*Palo Verde Nuclear Generating Station
Units 1, 2, and 3*

Improved Technical Specifications

PVNGS ITS
SECTION 3.7 - PLANT SYSTEMS

ITS REVIEW PACKAGE CONTENTS (Volume 13)

FIGURE 3.7.17-1
ASSEMBLY BURNUP VERSUS INITIAL ENRICHMENT

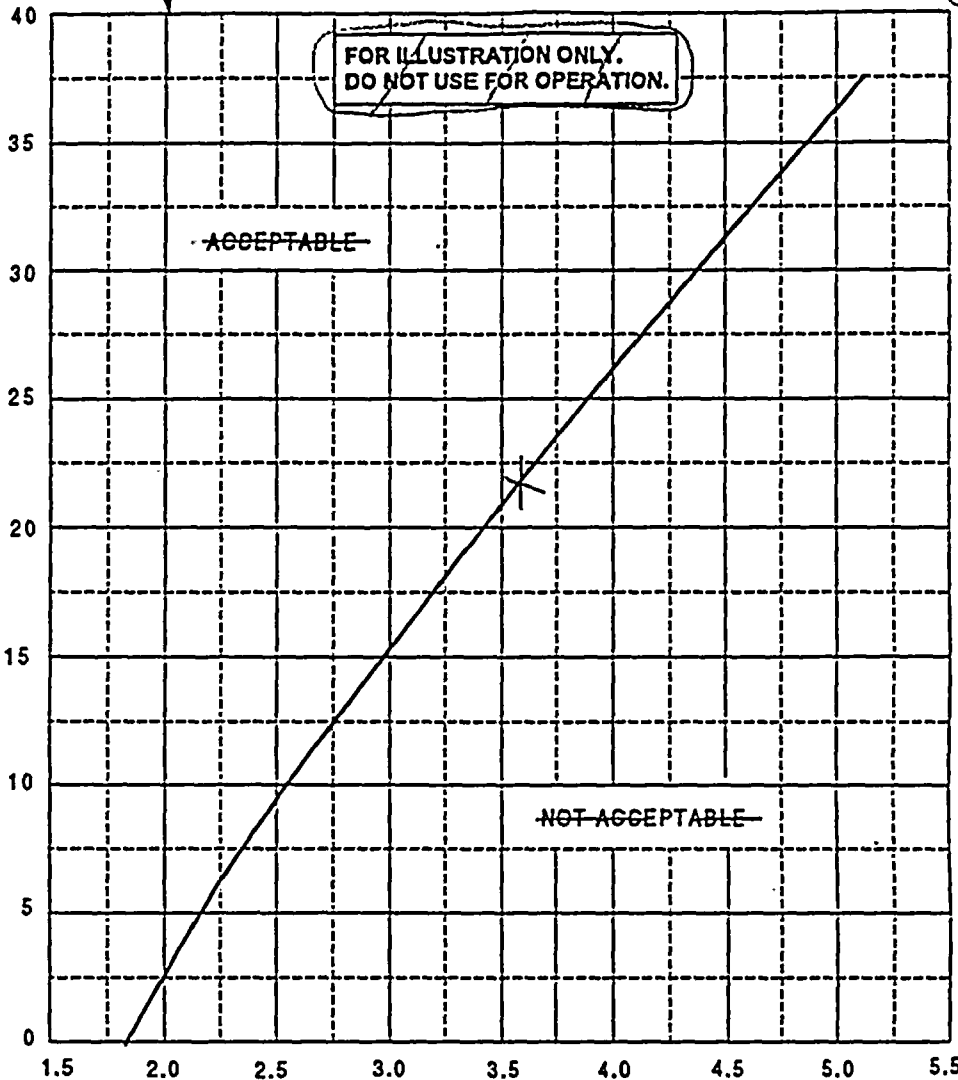
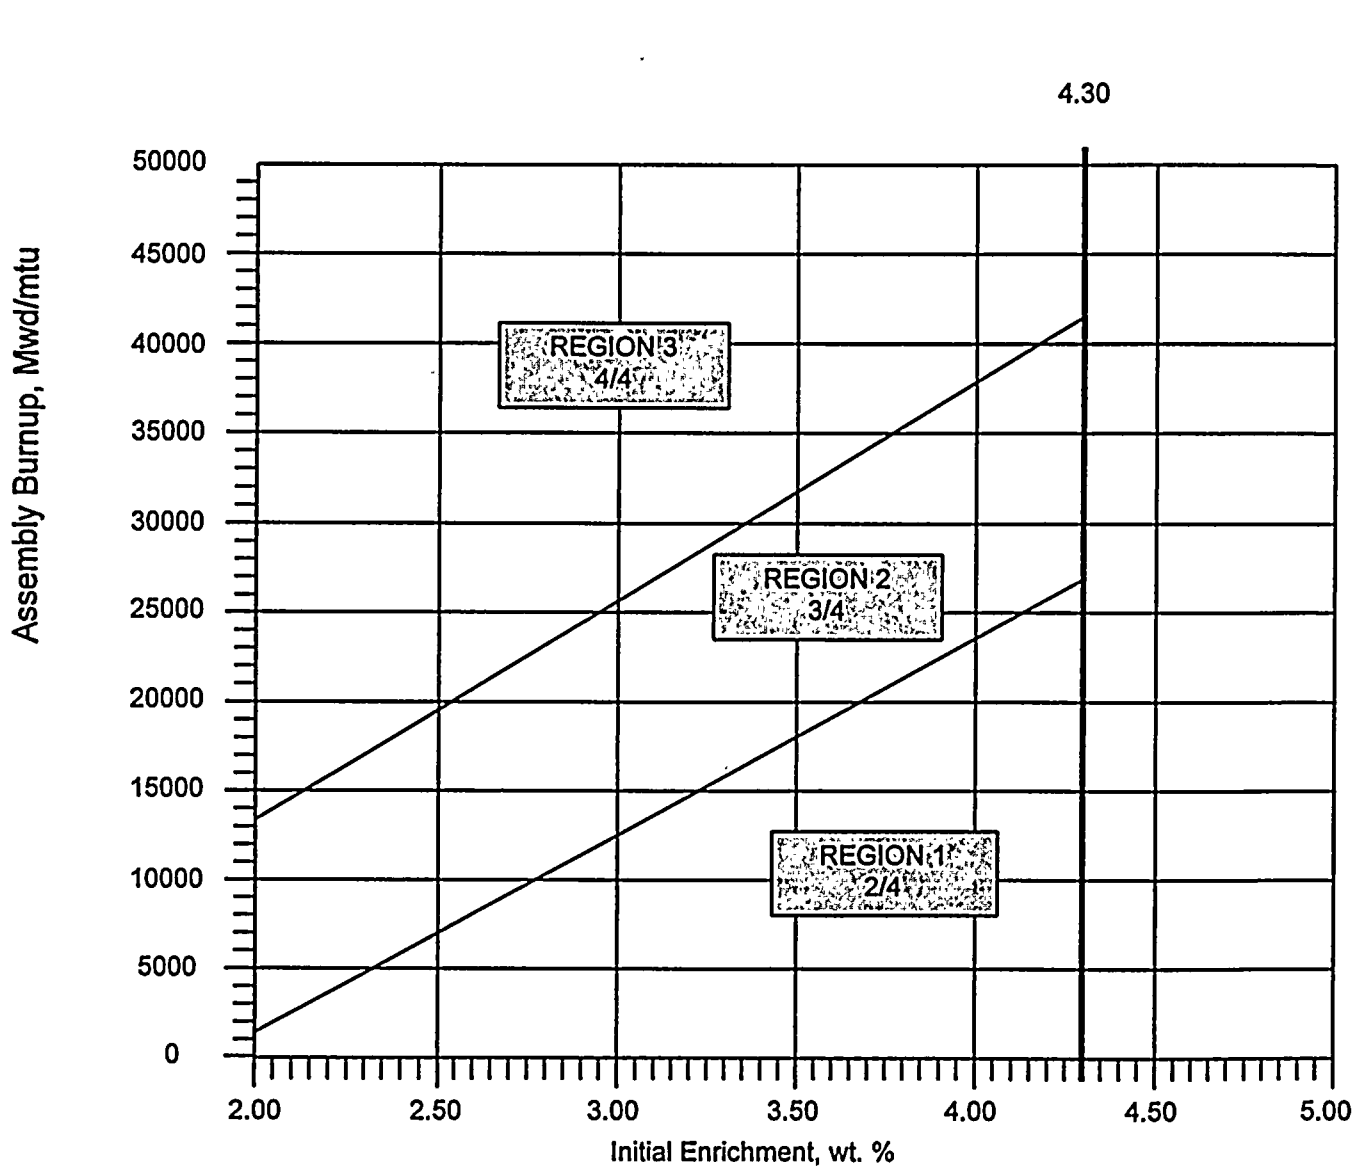
The combination of initial enrichment and burnup of each spent fuel assembly stored in [Region-2] shall be within the acceptable burnup domain of Figure 3.7.18-1 for in accordance with Specification 4.3.1.1. 17 and described in

(17)
Verify by administrative means the initial enrichment and burnup of the fuel assembly is in accordance with Figure 3.7.18-1 or Specification 4.3.1.1. (17) and | Prior to storing the fuel assembly in [Region-2] the spent fuel storage pool |

< Insert for Figure 3.7.17-1 >

FIGURE 5.3-1
ASSEMBLY BURNUP VERSUS INITIAL ENRICHMENT

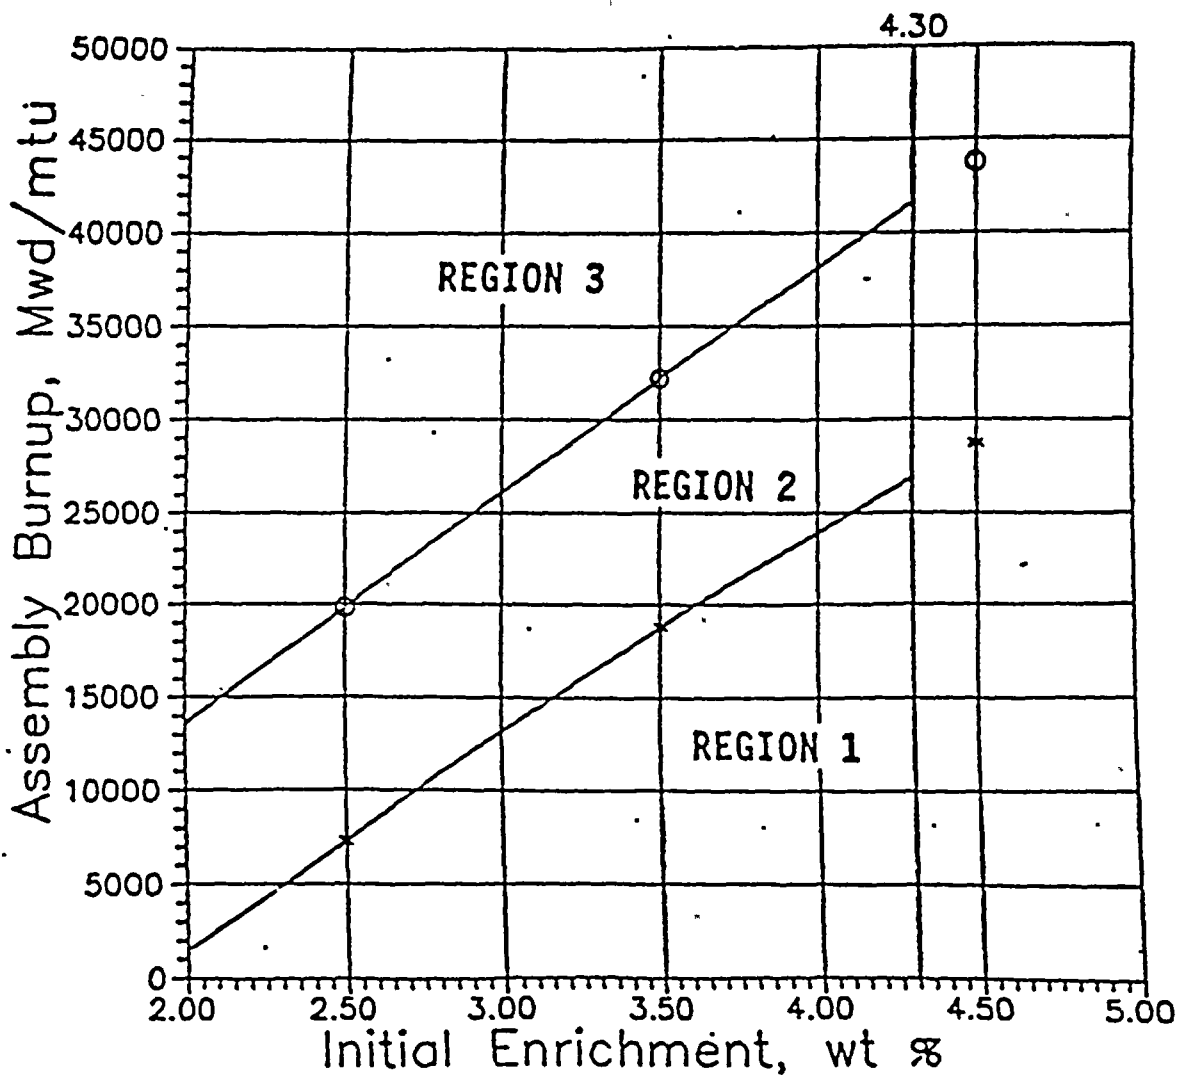
A.1

3.7.17-1
